**CONTRACT CHANGE ORDER**

| CCO No.<br><b>28</b> | Suppl. No. | Contract No.<br><b>76108/4076</b> | Project<br><b>Silver Springs Parkway Offsite<br/>(South Segment)</b> | Federal Number(s)<br><b>NA</b> |

PROFILE AND CROSS SLOPE MODIFICATIONS  
SCALE : 1" = 30' H.V

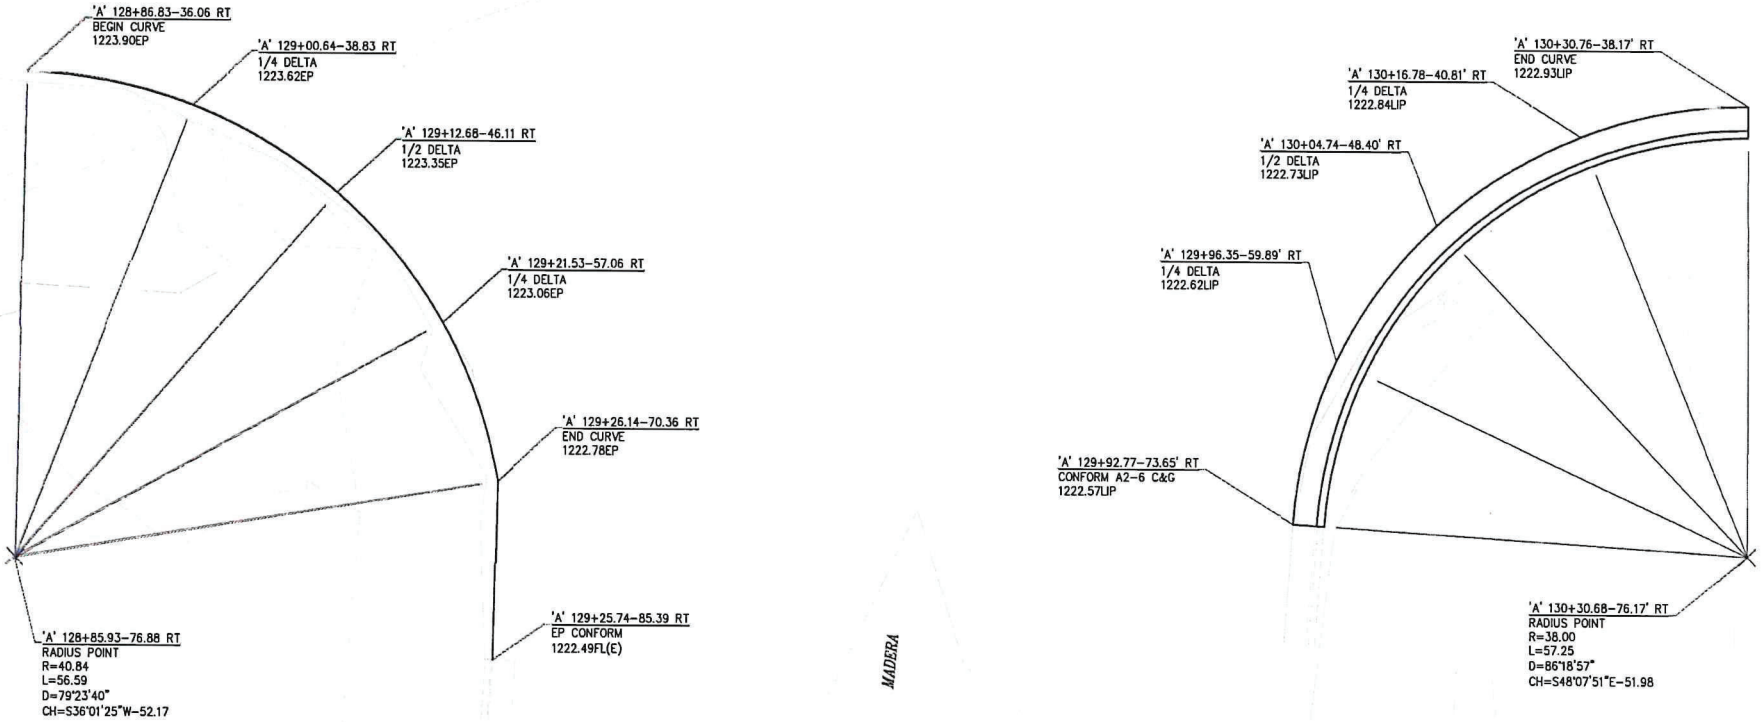
In accordance with Section 9-1.04, "Force Account," of the Standard Specifications, furnish necessary materials, equipment, labor, and construct a lift of hot mix asphalt (HMA) leveling course to switch public traffic safely back to Bass Lake Road. Perform the directed leveling course between "A" Line Station 124+60 and Station 131+60, and Madera Way between Bass Lake Road and Jasmine Circle/Summer Drive as shown on the exhibits, and as directed by the Engineer in such a way that the final product will bring new and the existing roadway grade at the same level for the traffic safety. Prior to the HMA leveling course, you must perform confirm grinding at Madera Way and Bass Lake Road, along the PG&E trench between "A" Line Station 126+47 to Station 128+27, and grinding depicted in the contract document. You must haul away and dispose of the ground HMA at an authorized disposal/recycling location, and stripe the traffic lanes, and install shoulder backing prior to Bass Lake Road open to the public traffic.
